35/B-OTM 14 W. IRVING C.G. VILLAGE

**MONTGOMERY COUNTY HISTORIC PRESERVATION COMMISSION**  
**STAFF REPORT**

<b>Address:</b>	14 Irving St, Chevy Chase	<b>Meeting Date:</b>	4/25/2007
<b>Resource:</b>	Non-Contributing Resource <b>Chevy Chase Village Historic District</b>	<b>Report Date:</b>	4/18/2007
<b>Applicant:</b>	Chris & Patricia Abel (Robert Lach, AIA)	<b>Public Notice:</b>	4/11/2007
<b>Review:</b>	HAWP	<b>Tax Credit:</b>	N/A
<b>Case Number:</b>	35/13-07M	<b>Staff:</b>	Michele Oaks
<b>PROPOSAL:</b>	House Construction

**RECOMMENDATION:** Approve with Conditions

29
**Proposed First Floor Plan**  
 Able Residence 14 West Irving Street, Chevy Chase Village

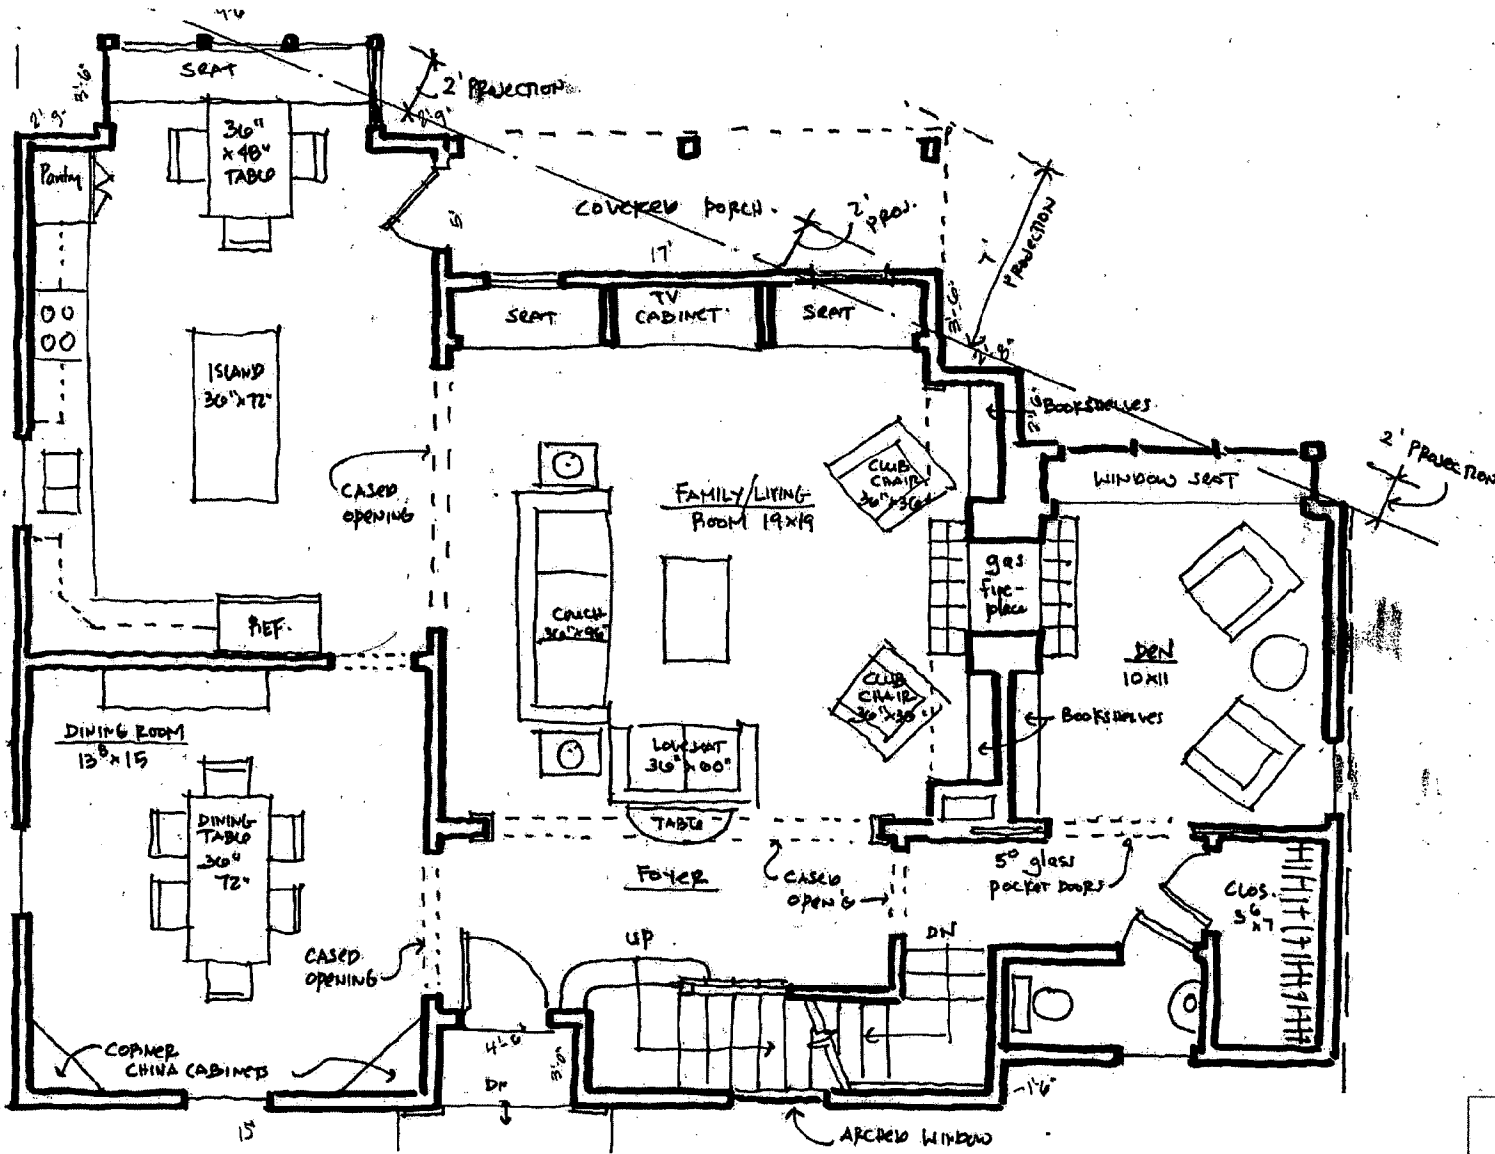
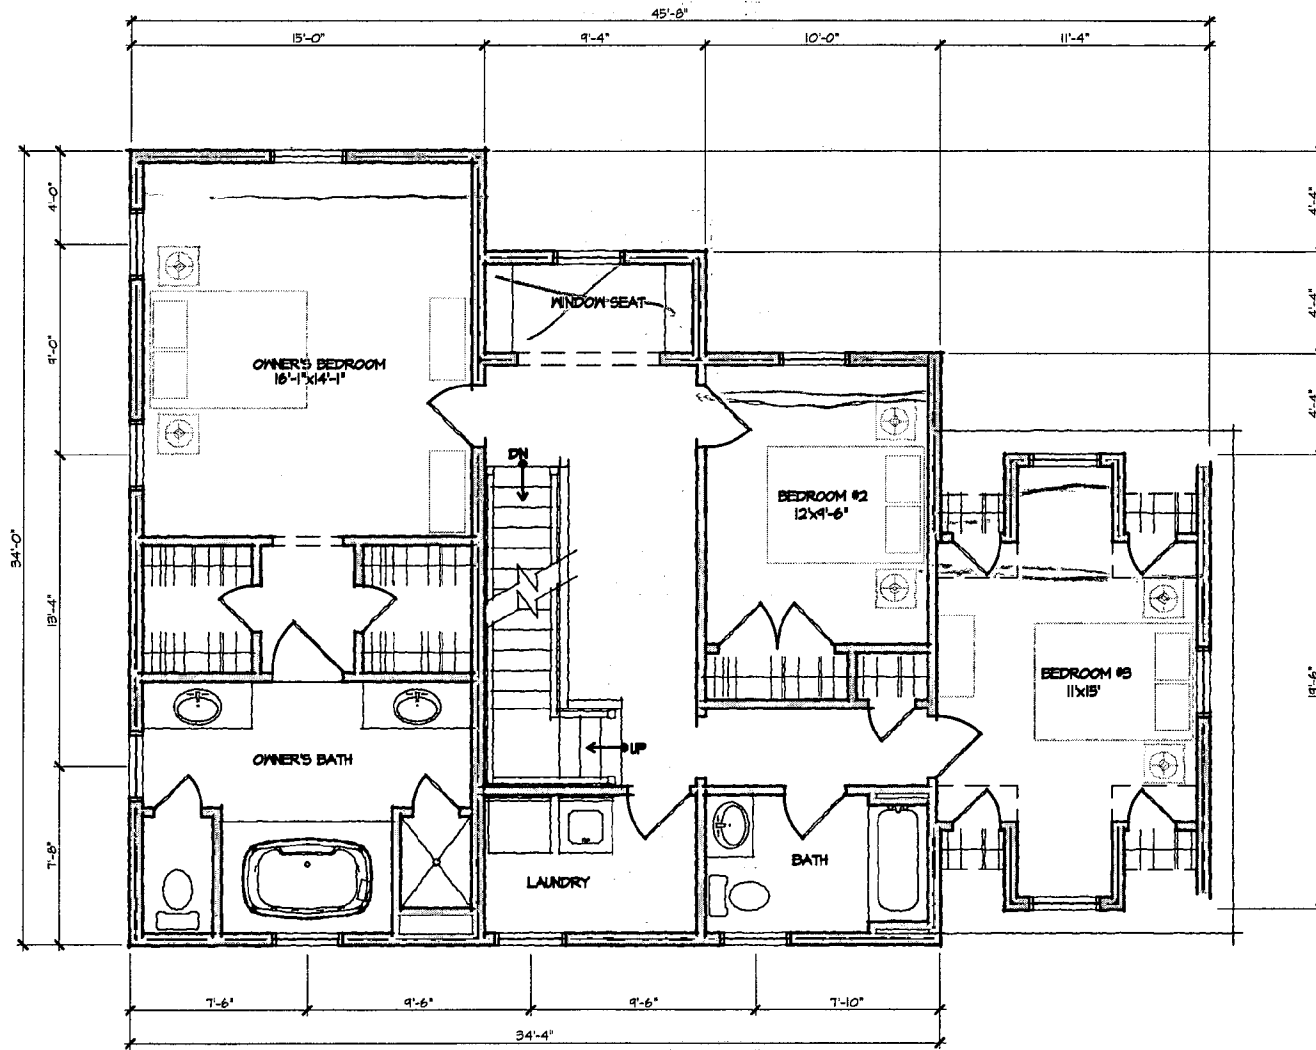
1. The entry has changed from a side entry to a central entry.
2. An arched window has been added to the right section of the façade to detail the stairwell.

# Proposed Front Elevation

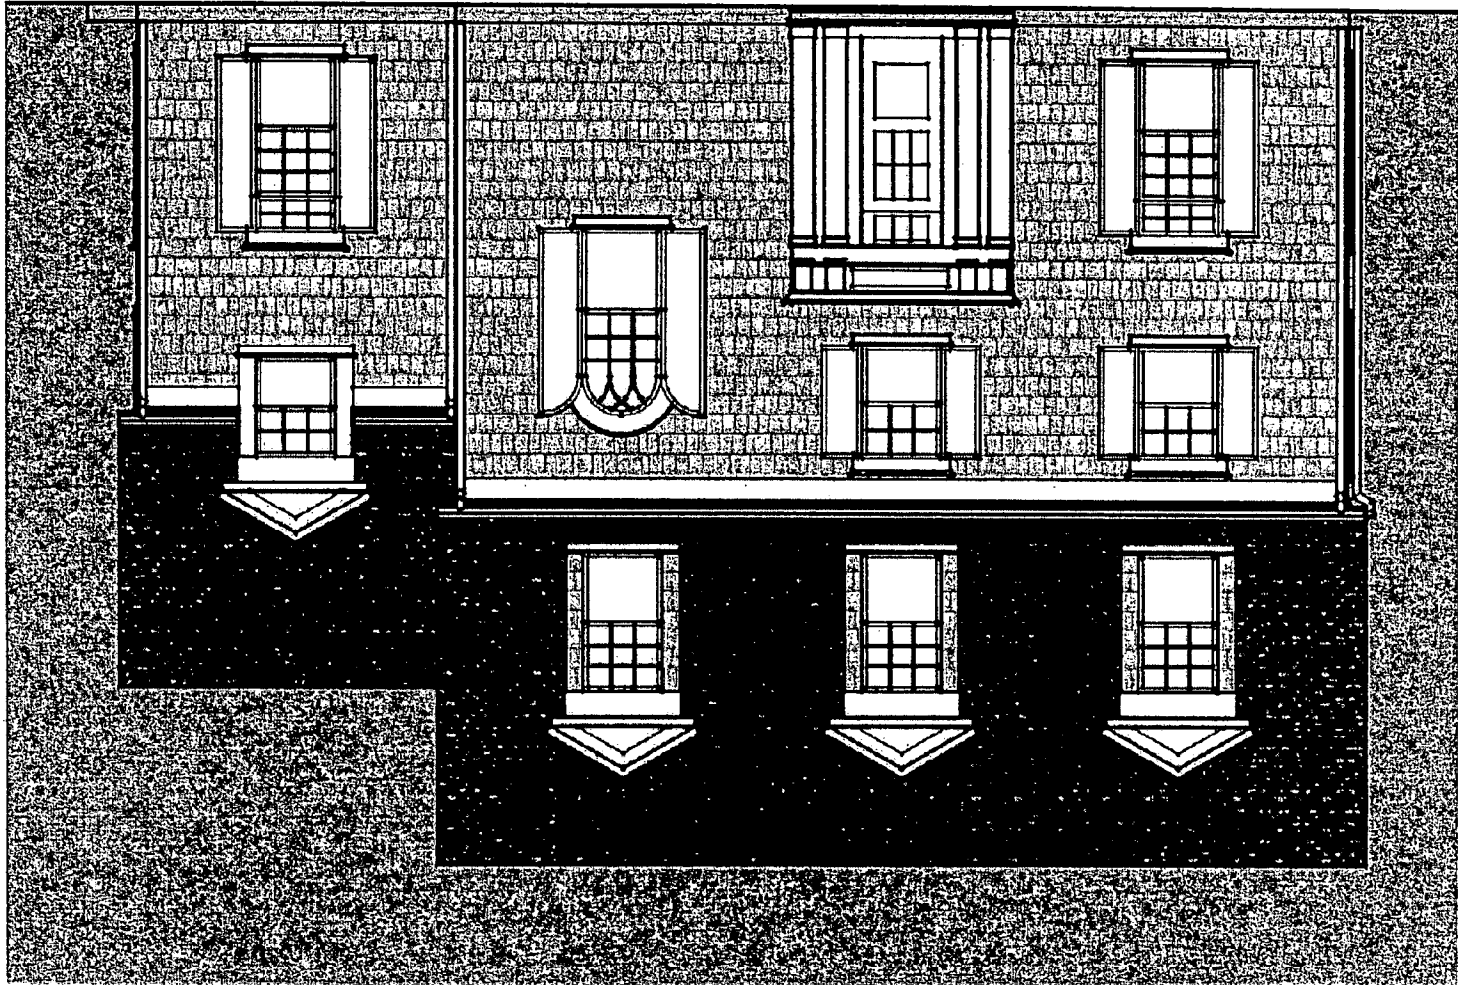
1. The entry has changed from a side entry to a central entry.
2. An arched window has been added to the right section of the façade to detail the stairwell.
